To: Greater Cambridge Partnership
Authors: Edward Leigh, Jim Chisholm, Sam Davies, Chris Rand et al
Date: 9 April 2018
Subject: Response to Cambridge South East Transport Study consultation 2017/18
Contact: 01223 312 377 / edward@smartertransport.uk / [@SmarterCam](https://twitter.com/SmarterCam)

Appendix 1: Map of proposed interventions

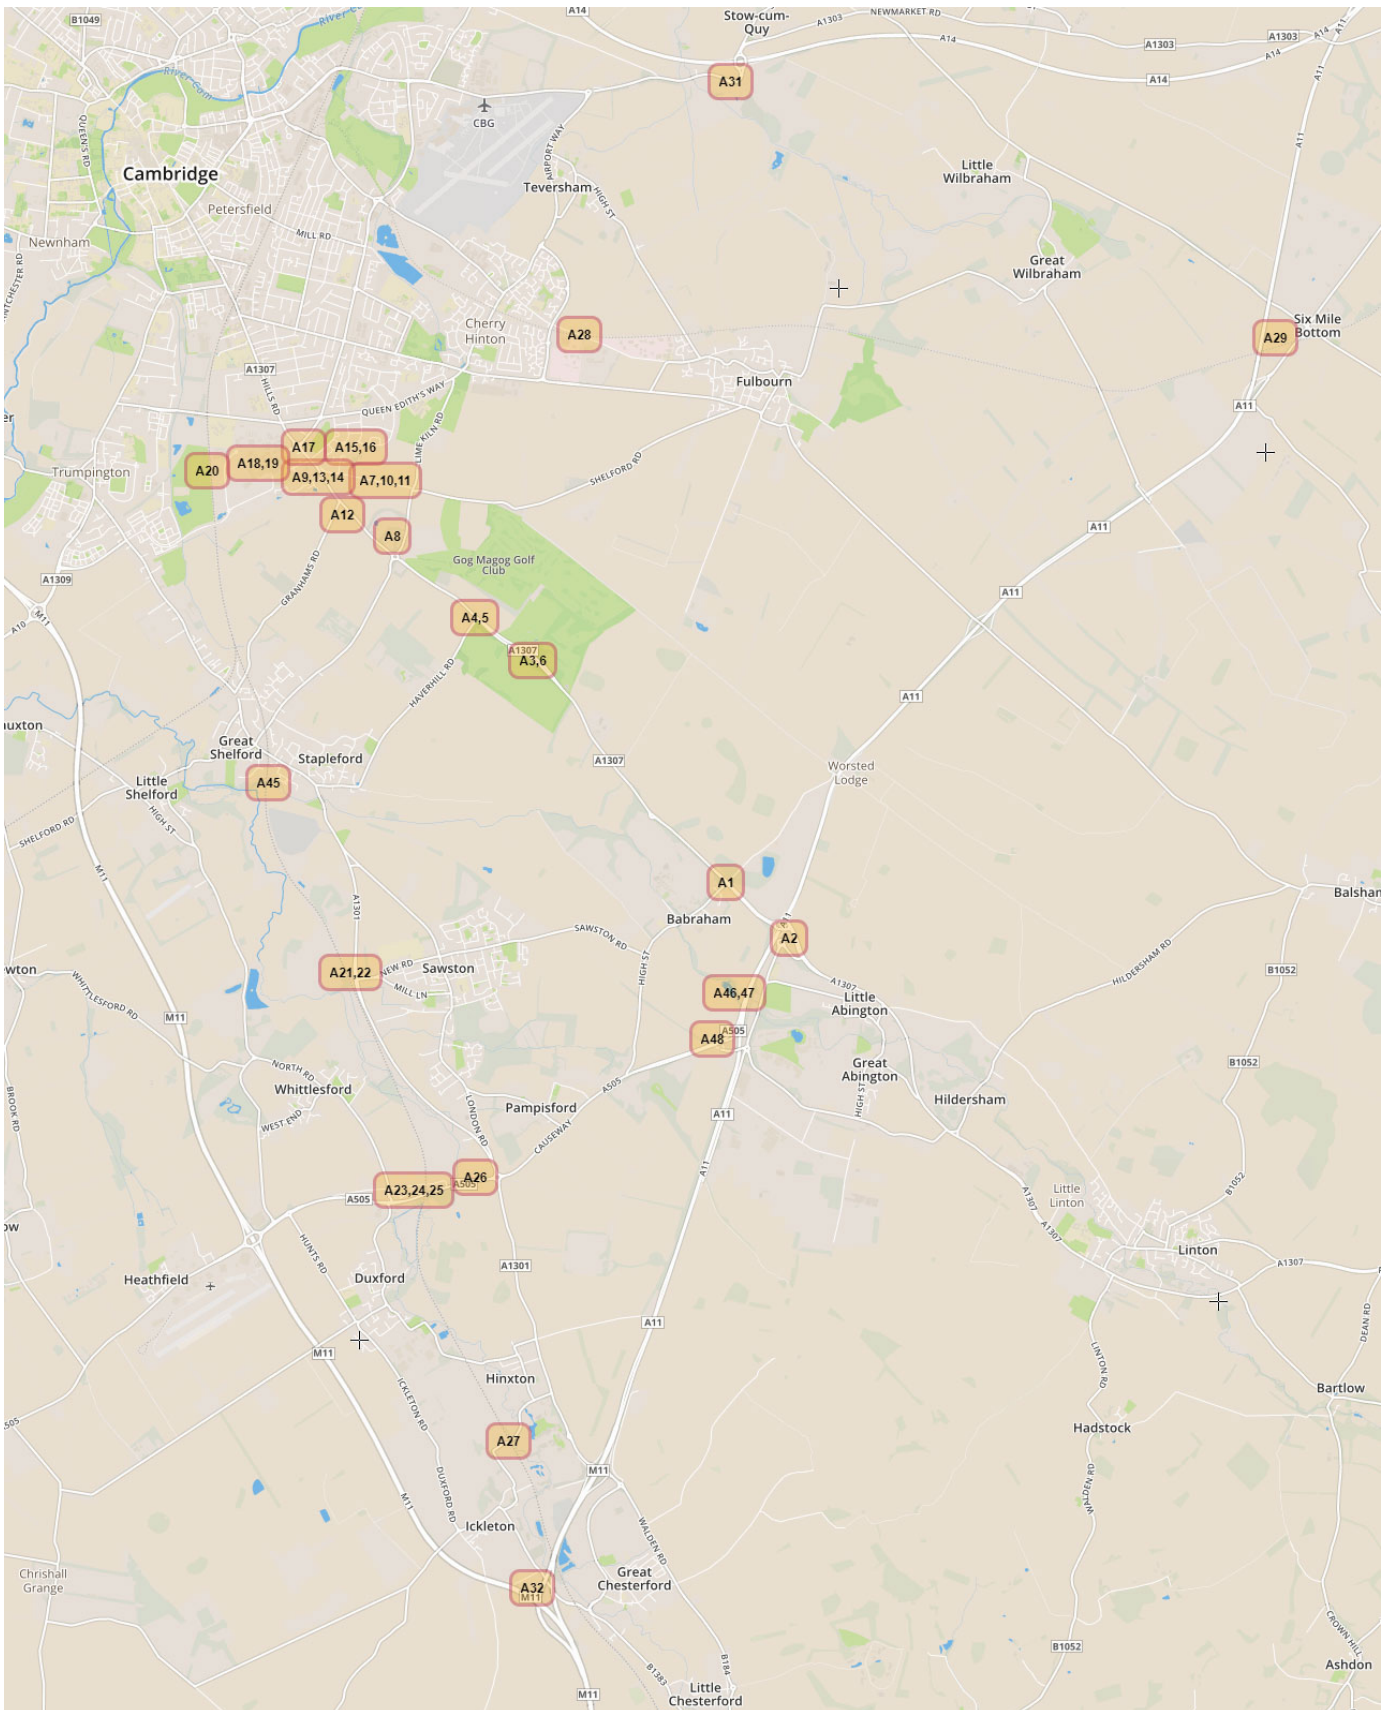
We see Strategy 3 as a viable short-to-medium term measure if road widening is avoided as far as possible, and alternative measures are introduced to increase bus priority and safety for all road users. We call this ‘Strategy 3a’. Interventions are shown on a map in Appendix 1.

Figure 7: Peak-time bus route, bypassing queues on Babraham Rd

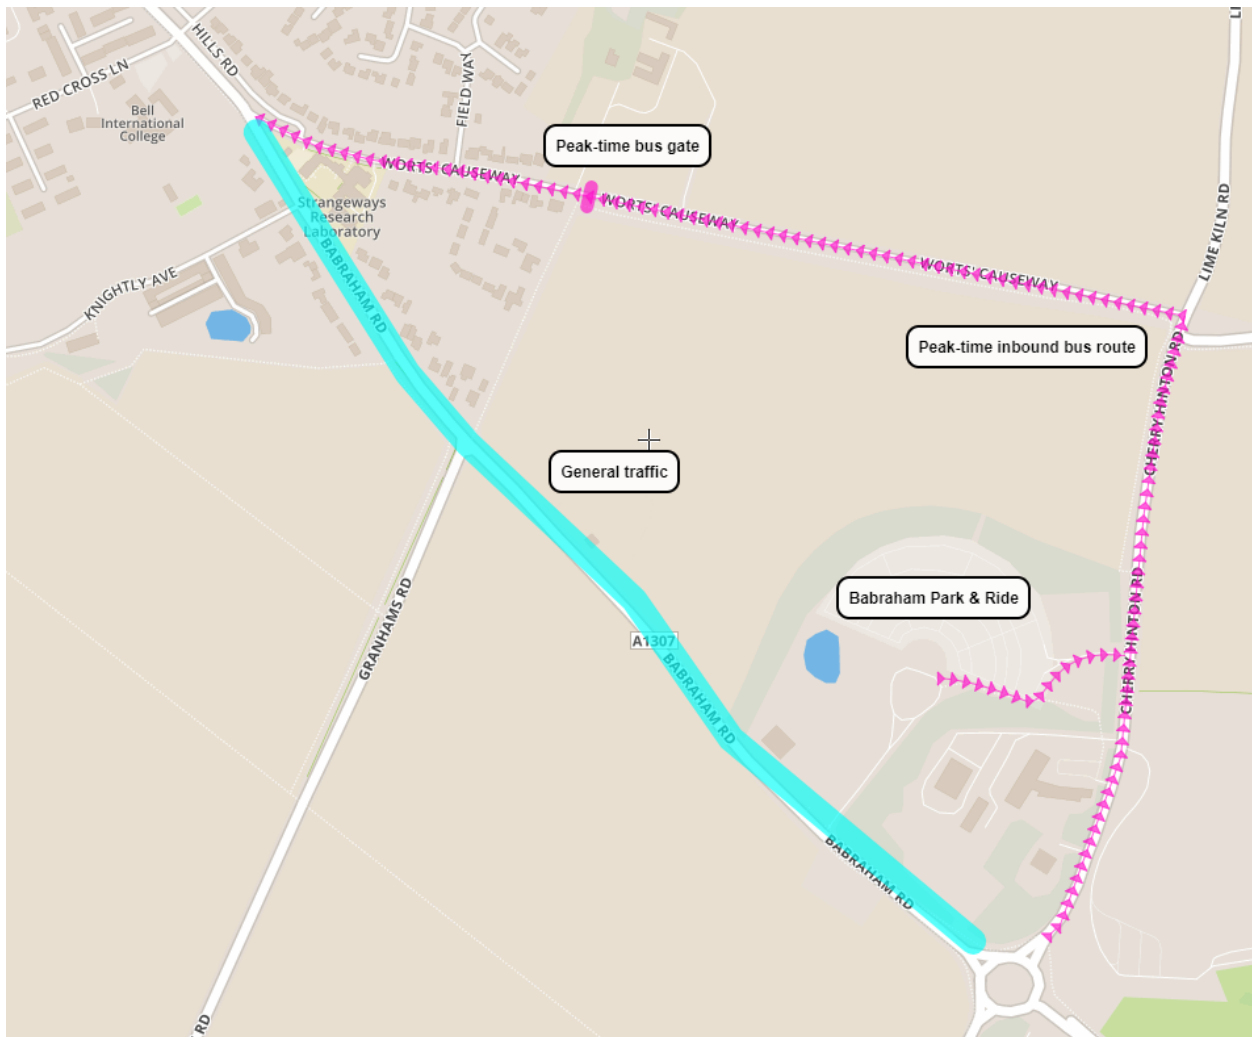
- A7. Update the existing access restriction on Worts' Causeway to act as a bus gate during peak hours. At these times, the only vehicles using Worts' Causeway east of the bus gate (where there are no houses) would be buses travelling towards the city. This would include services from Babraham P&R and Haverhill (service 13). Consult with local residents about extending the hours of restricted access to deter rat-running. See figure 7.

- A8. Within Babraham P&R, add an outbound bus lane from the bus station alongside the car park entry lane to enable buses to exit directly onto Cherry Hinton Rd at peak times. This would give buses access to Cambridge via Worts' Causeway, avoiding congestion on Babraham Rd. The detour would be just 430m (about 45 seconds).

Figure 8: Possible location for a bus turnaround for Whittlesford Parkway station

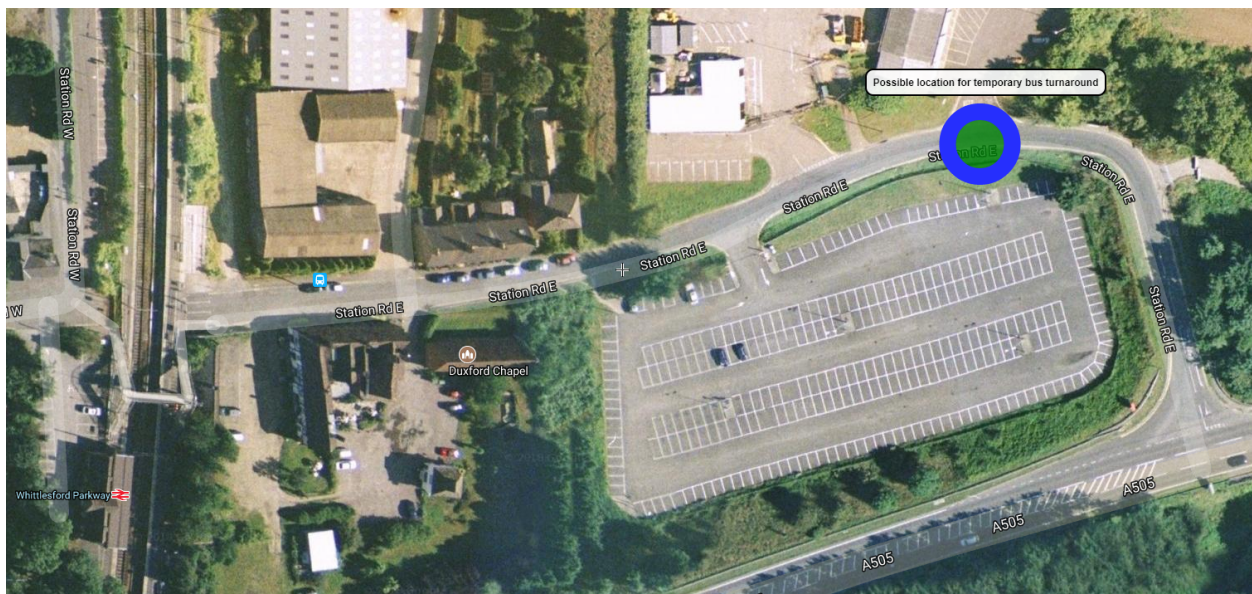
A42. Discuss with Granta Park and IWM Duxford subsidising a shuttle service along the A505 between the two locations, calling at Whittlesford Parkway station (with a bus turning circle – see Figure 8). A single bus could provide a 20–30 minute frequency service.

Figure 9: Possible new routes for 7 and 7X (express) bus services

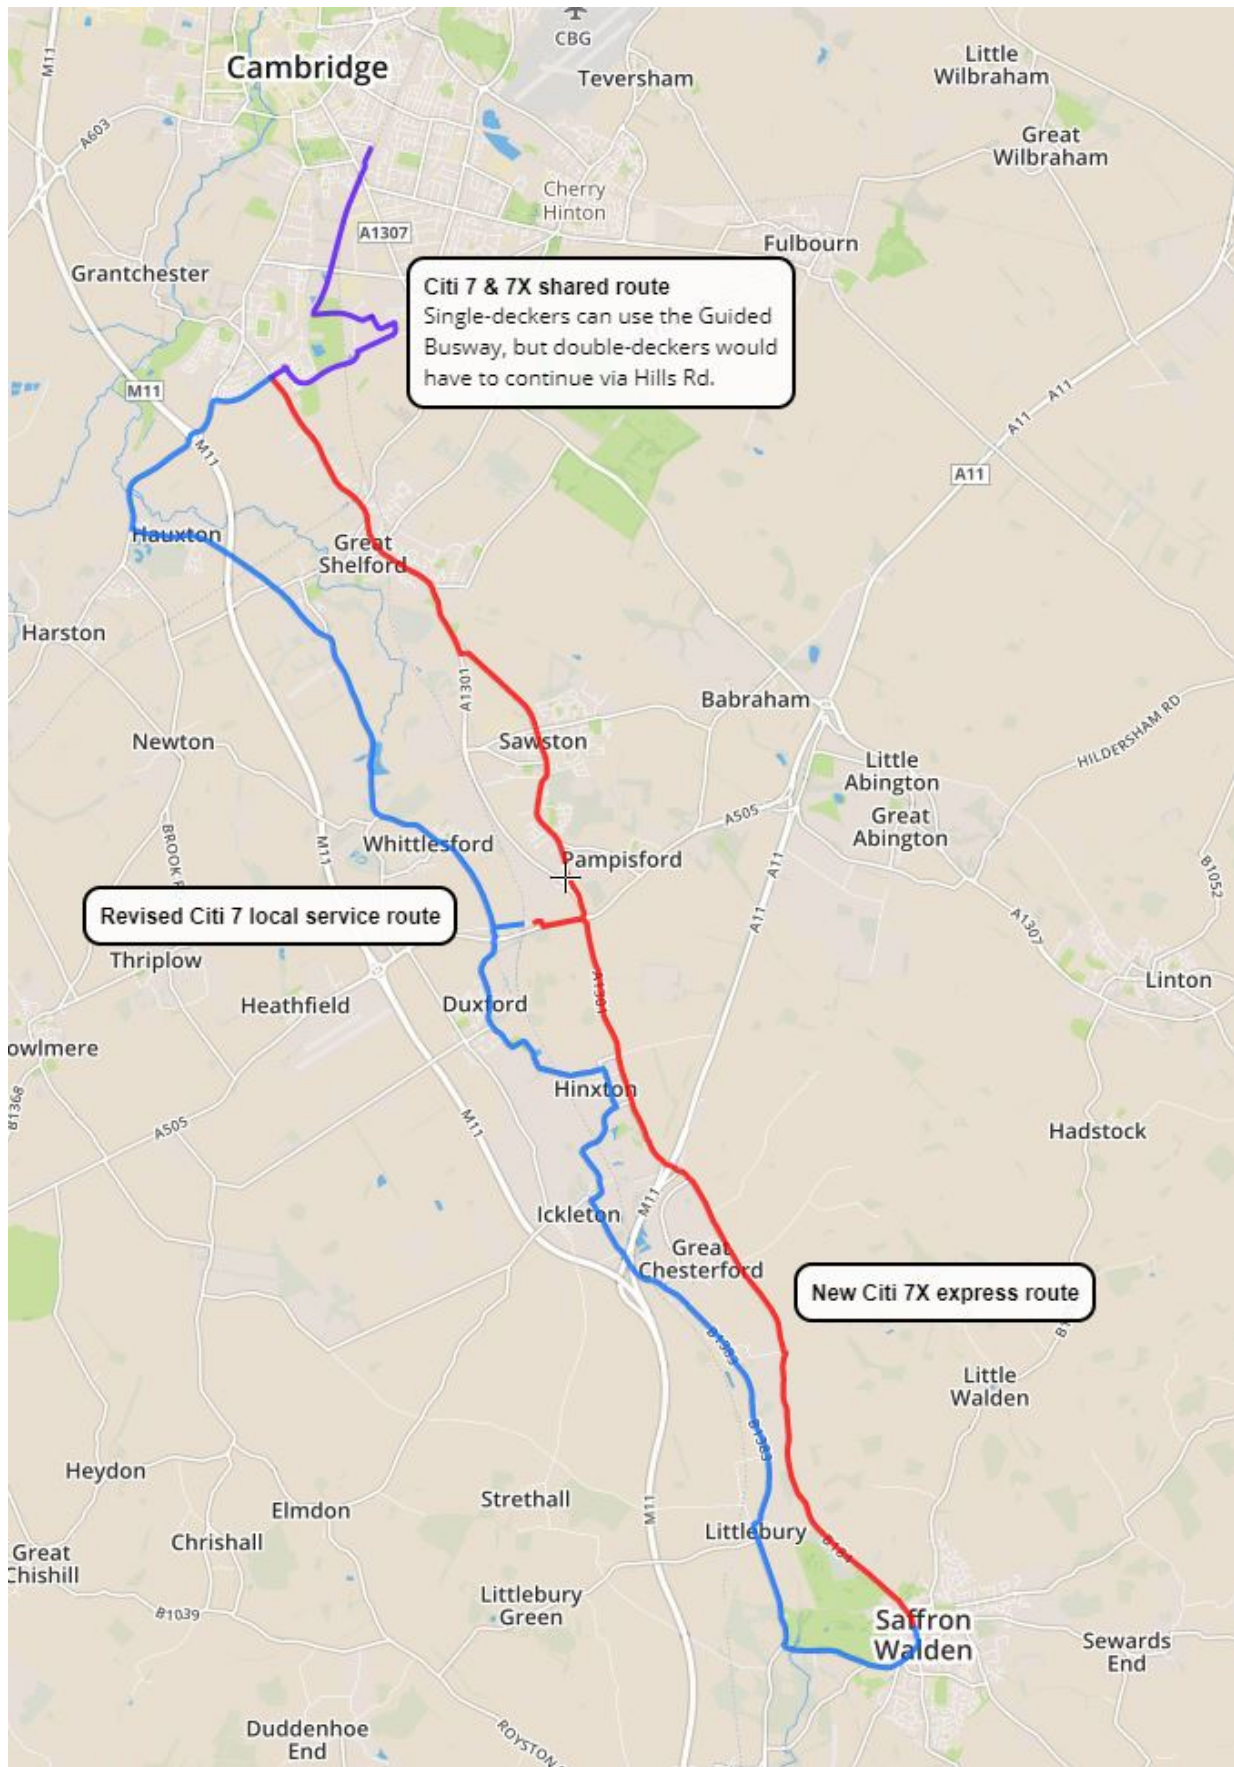
A36. Split the Citi 7 service into two services from Saffron Walden: Citi 7X ('express' via the B184 and A1307) and 7 ('local' via villages between the M11 and B184/A1301) – see Figure 9 for a map of these:

- **Citi 7X:** hourly (half-hourly at peak times) from Saffron Walden via Great Chesterford, Wellcome Genome Campus (stop on roundabout), Hinxton*, Whittlesford Parkway, Sawston, Stapleford, Great Shelford, Biomedical Campus, Cambridge station, Cambridge city centre.
- **Citi 7:** hourly from Saffron Walden via Audley End Estate, Littlebury, Great Chesterford station, Ickleton, Hinxton, Duxford, IWM Duxford, Whittlesford Parkway (as close as possible to the station, ideally using a turnaround on Station Rd West), Whittlesford, Little Shelford, Great Shelford, Biomedical Campus, Cambridge station, Cambridge city centre.
